Update Figures 33-14x

IEEE802.3bt
October 2015

Yair Darshan

- Objective
 - Update Figures 33-14 with its variations to capture PSE types 1-4.

Figure 33-14—POWER_ON state, per pairset operating current templates for PSEs that operate in 2-pair mode, Type 3 and Type 4 dual-signature PSEs

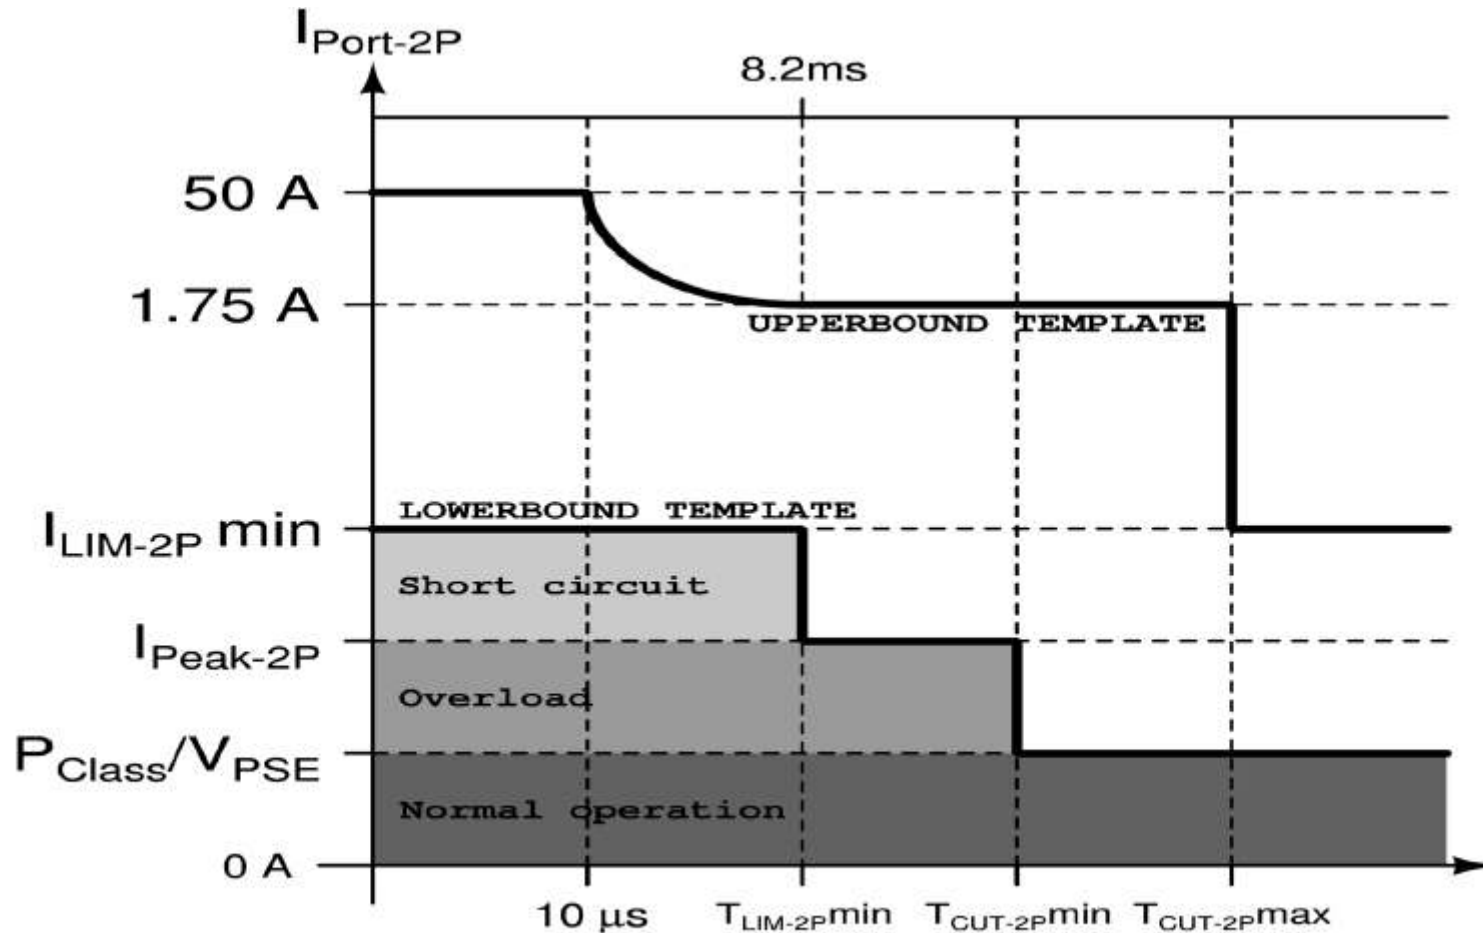
Replace Figure 33-14 title with:
 Figure 33-14 – POWER_ON state, operating current templates for Type 1 and Type 2 PSEs

Figure 33-14a—POWER_ON state, per pairset operating current templates for Type 3 PSEs in 4-pair mode connected to single-signature PDs

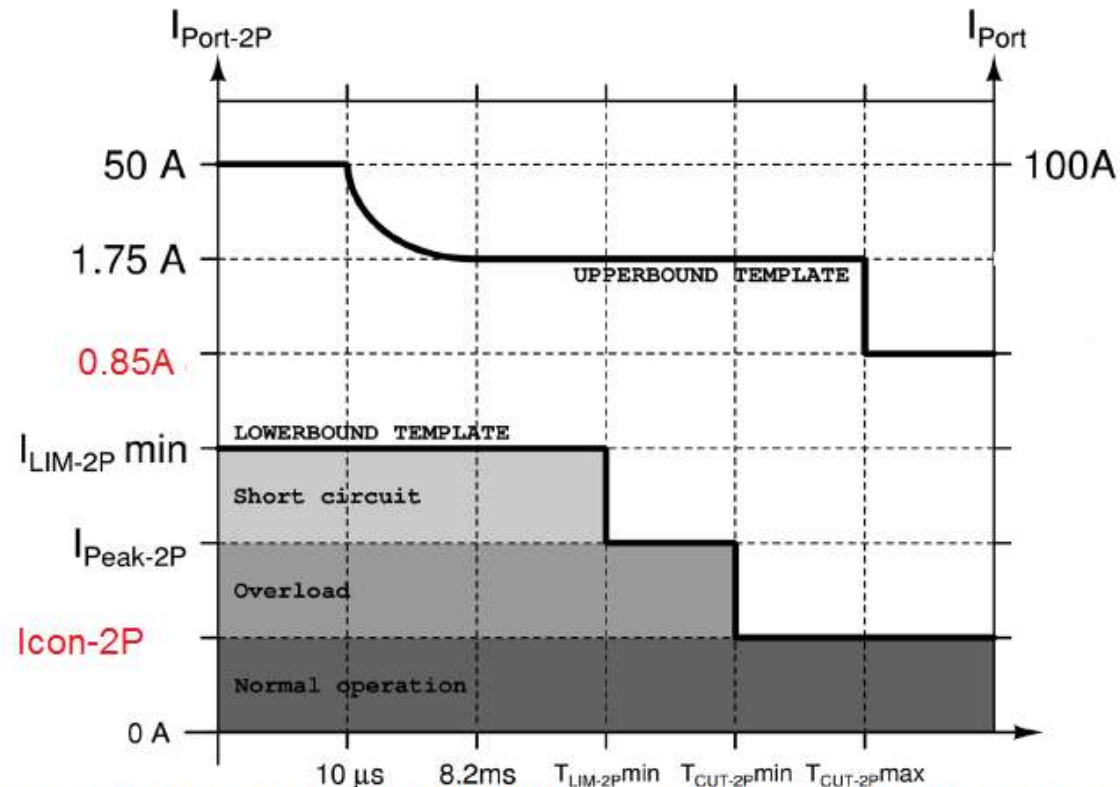
Insert new Figure 33-14a as follows:

1. Replace Figure 33-14a title with:
Figure 33-14a – POWER_ON state, operating current templates for Type 3 and Type 4 PSEs operating in 2P-mode or Type 3 and 4 PSEs operating in 4P-mode when connected to dual signature PD with different class signature on each pairset.
2. Update the red text in the drawing

Figure 33-14b – POWER_ON state, operating current templates for Type 3 PSEs operating in 4P-mode and connected to single signature PD, or connected to dual signature PD with the same class per pairset.

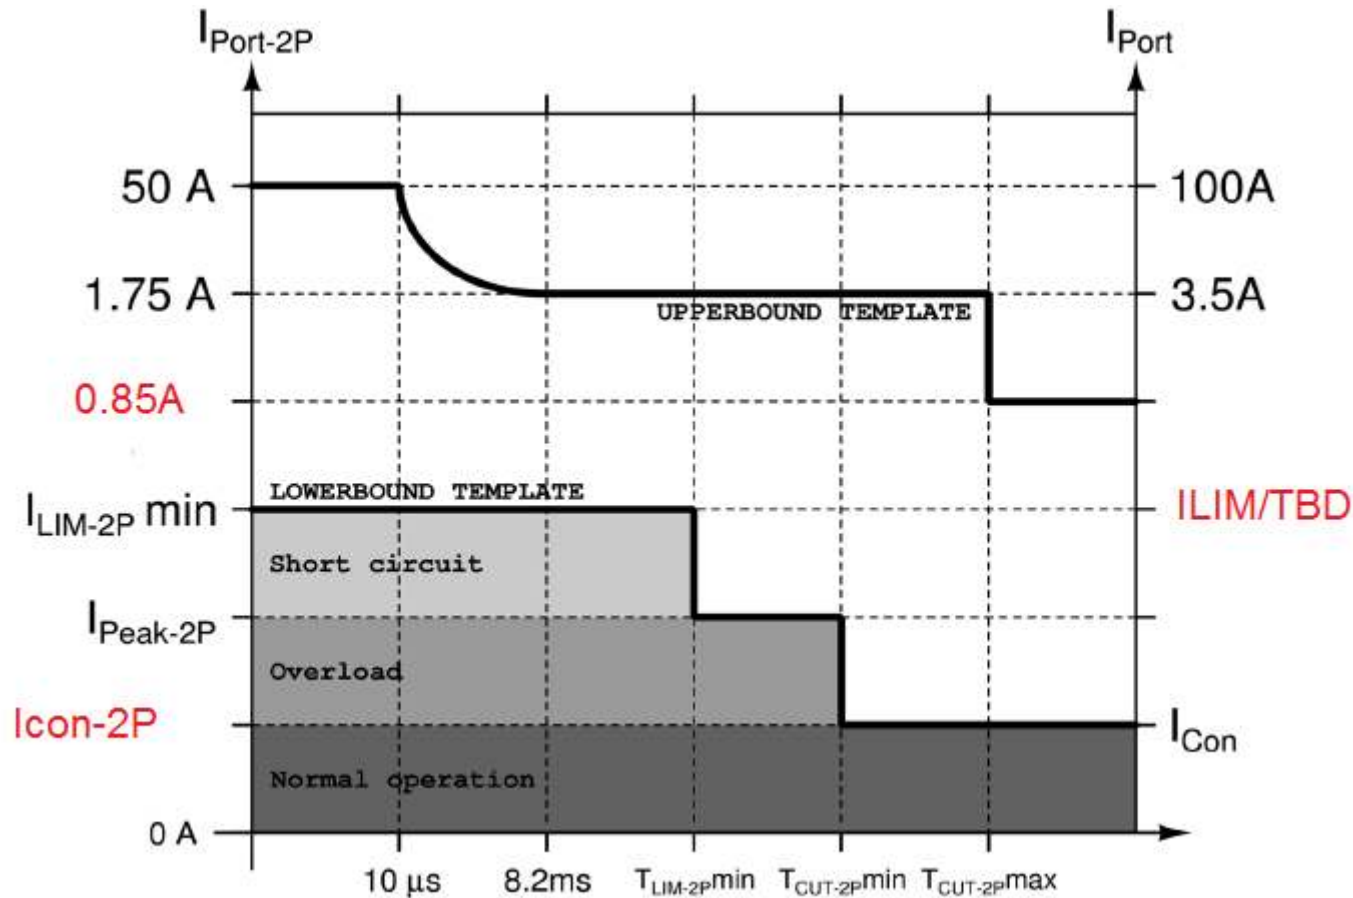
Insert new Figure 33-14b as follows:

Figure 33-14c – POWER_ON state, operating current templates for Type 4 PSEs operating in 4P-mode and connected to single signature PD, or connected to dual signature PD with the same class per pairset.

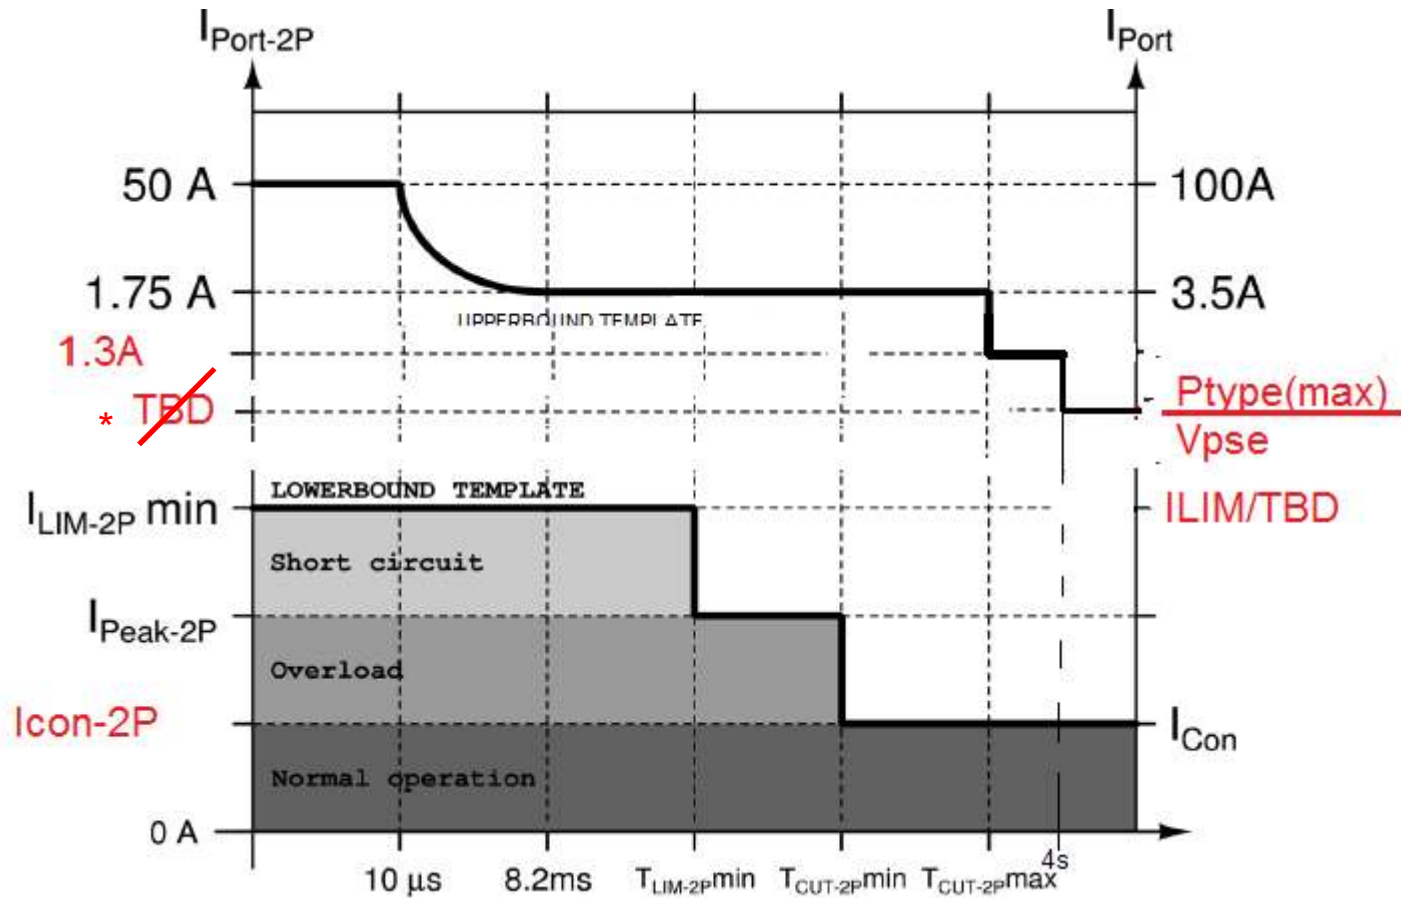
Insert new Figure 33-14c as follows:
